|  | <p>1835 38<sup>th</sup> Street<br/>Boulder, CO 80301<br/>(720) 565-6885</p> | <b>Bulletin No:</b> TSB 0006                                   |

# NOTIFICATION

| <b>Equip. Name:</b> zipSTOP and zipSTOP IR Zip Line Brake        | <b>Affected Serial No:</b> All zipSTOP and zipSTOP IR zip line brakes |

**Abstract of Issue:**  
zipSTOP Manual P/N 01170006603 (Revision 3) included a mis-labeled image on page 36 with load values transposed from the written description.

Figure 1

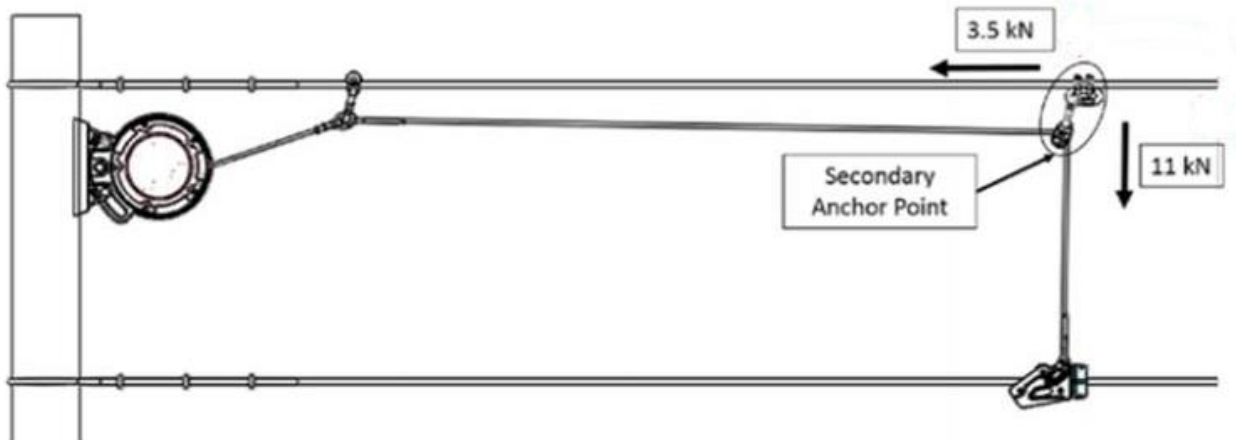
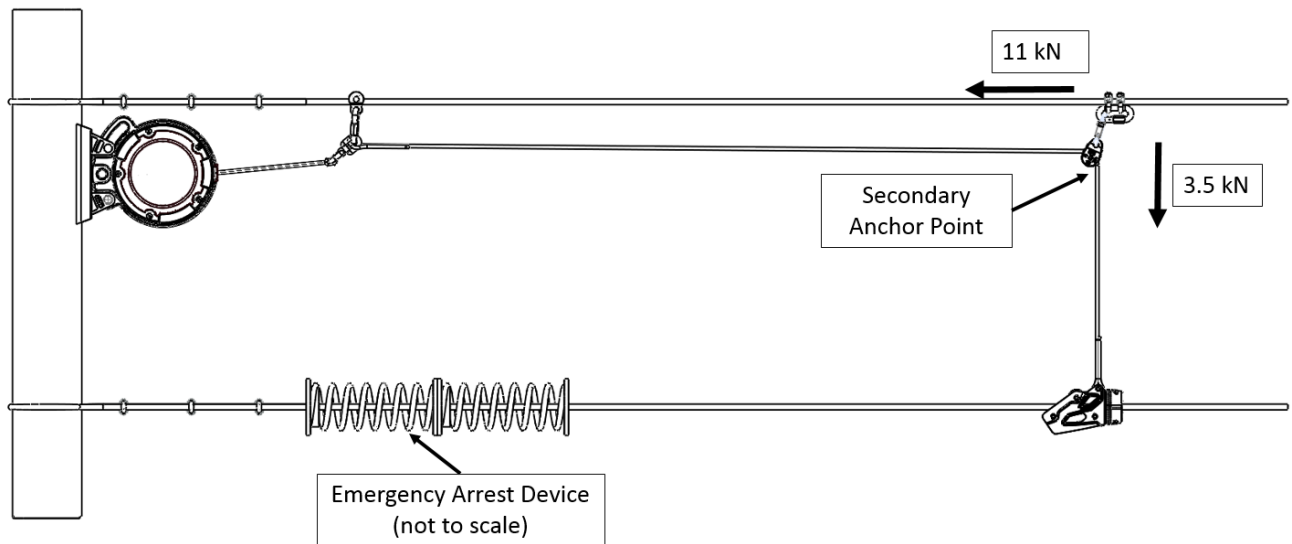
**Detail of Issue:** The following image (Figure 1) was added in the zipSTOP Manual P/N 01170006603 (Revision 3) published in February 2017:

This image does not match the written description that is stated in zipSTOP Manual P/N 01170006601-01170006604 (Revision 1-4). The load values, 11.0 kN and 3.5 kN are transposed in the image.

The updated image (Figure 2) in zipSTOP Manual P/N 01170006604 (Revision 4) has the load values, 11 kN and 3.5 kN correctly placed.
